1. 7:00 P.M. Agenda For The September 21, 2020 Meeting Of The Zoning Board Of Appeals

1.I. Appeal 2232 - SUP 22 Durkee Street

[PUB COMMENT 4.6.20 - DURKEE SUPPORT.PDF](#)
[PUB COMMENT 4.6.20 - PAUSE NY.PDF](#)
[PUB COMMENT 4.6.20- DURKEE OPPOSITION.PDF](#)
[PUBLIC COMMENT 4.20.20 DURKEE OPPOSTION.PETITIONS.PDF](#)
[PUBLIC COMMENT 4.20.20 DURKEE PETITION - DOWNSIZE PROPOSED DURKEE MIXED USE DEVELOP.PDF](#)
[PUBLIC COMMENT 4.20.20 DURKEE PETITION - STOP PRIME DEVELOPMENT OF DURKEE ST PARKING LOT.PDF](#)
[PUBLIC COMMENT 4.20.20 DURKEE ST - WEST ELEVATION AND SITE PLANS.PDF](#)
[PUBLIC COMMENT 4.20.20 DURKEE STRONG TOWN PLATTSBURGH - LOCAL BUSINESS PETITION.PDF](#)
[PUBLIC COMMENT 4.20.20 PETITION - CHANGE DURKEE MIXED LOT.PDF](#)
[PUBLIC COMMENT 4.6.20- 22 DURKEE ST - ATTORNEY FULLER LETTER.PDF](#)
[5-11 COVER LETTER.PDF](#)
[5-11-20 DURKEE ST 1.PDF](#)
[2020-05-11 DURKEE STREET-1.PDF](#)
[18491.00-2020-05-11 COVER LETTER - ZBA.PDF](#)
[ORIGINAL APP.PDF](#)
[SITE PLAN FROM MARCH.PDF](#)
[18491.00-2020-08-10-REVISD SITE PLAN SUBMISSION.PDF](#)

DRAWING NUMBER
C-01

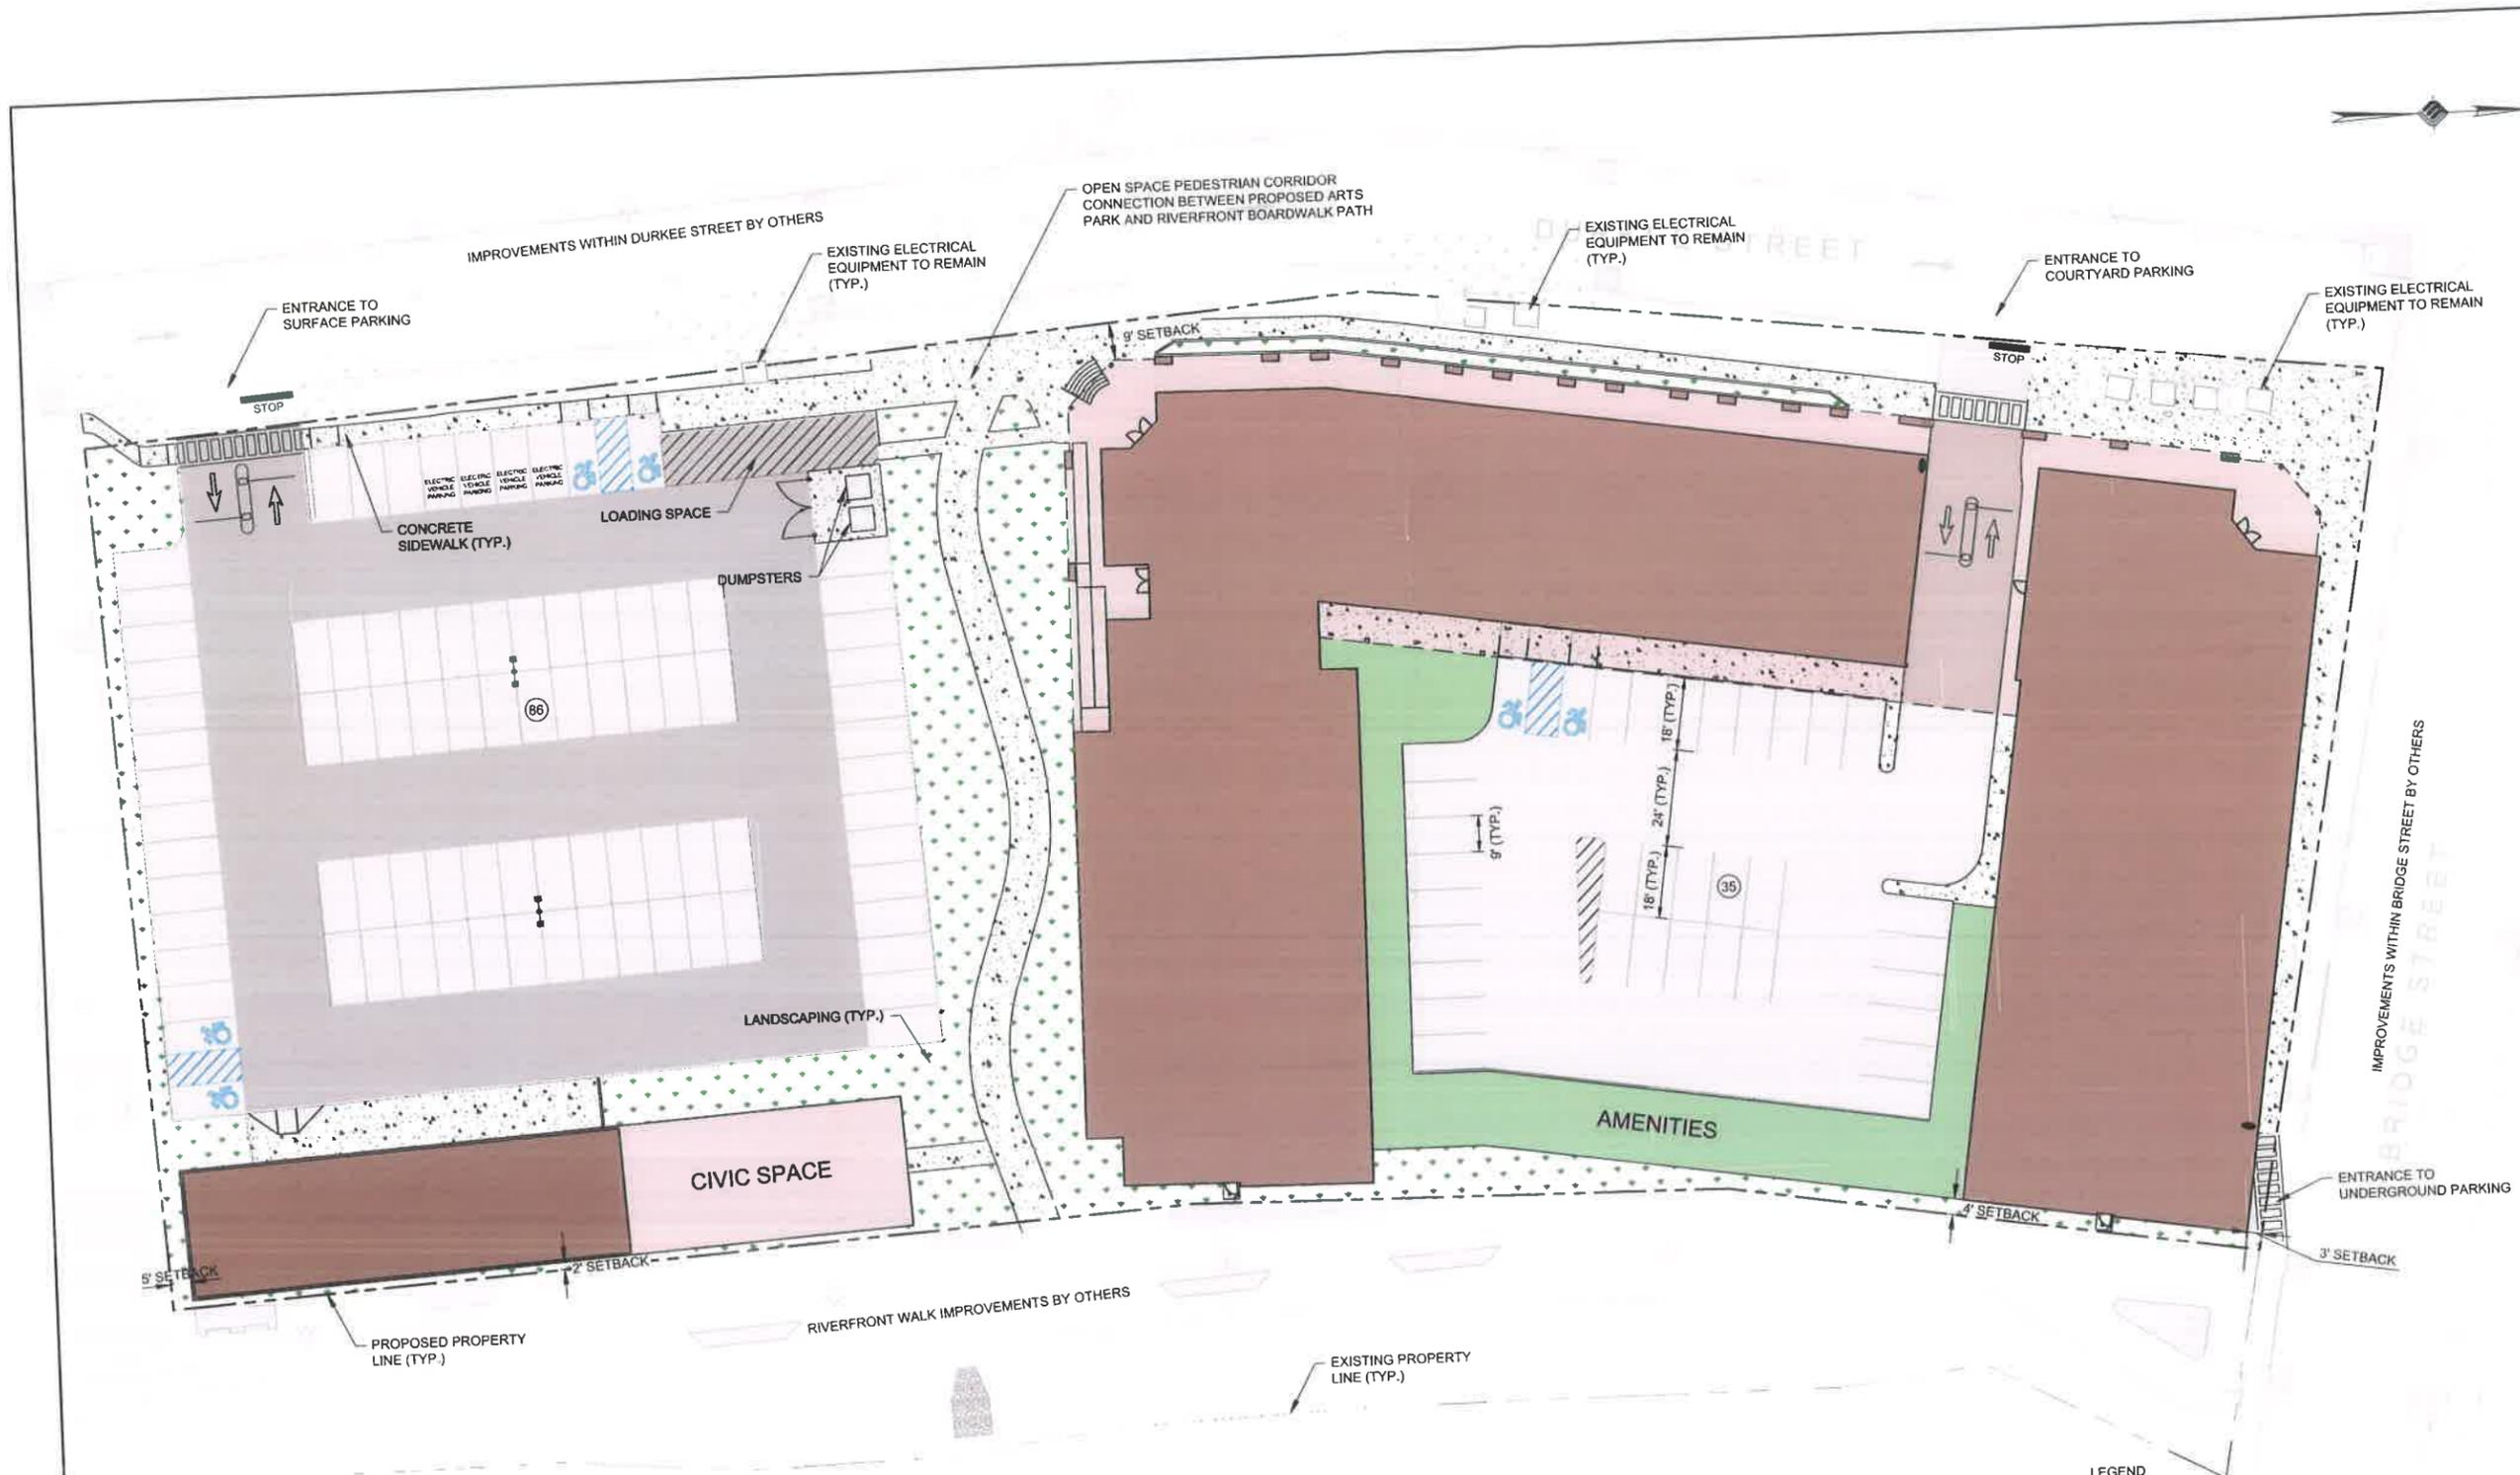
9. Please add dimensions to all existing and proposed buildings, parking areas, and public spaces (sidewalks and pedestrian corridor).
Dimensions have been added to the Site Plans and are shown on sheet C-01.

10. Please show all required/provided setbacks.
Setbacks have been added to the Site Plans and are shown on sheet C-01.
11. Please provide a stormwater management plan, which complies with NYSDEC stormwater regulations.
A full Stormwater Pollution Prevention Plan (SWPPP) has been prepared and is included with this submission.

18. Please provide an erosion control plan.
Erosion control plans provided, see sheets EC-01 and EC-02.
19. It is recommended that the Applicant be required to show proposed snow stockpile areas on the plan.
Snow stockpile areas have been provided and are shown on Site Plan sheet C-01.

32. Please identify any on-site playground amenities for residents.
No on-site playground amenities are included.
33. It is recommended the project provide two (2) bike racks for public use on site.
Bike rack locations are shown on sheet C-01.

34. Please provide additional information and note on the map any on site electric vehicle charging stations.
Electric vehicle charging station locations are shown on sheet C-01.
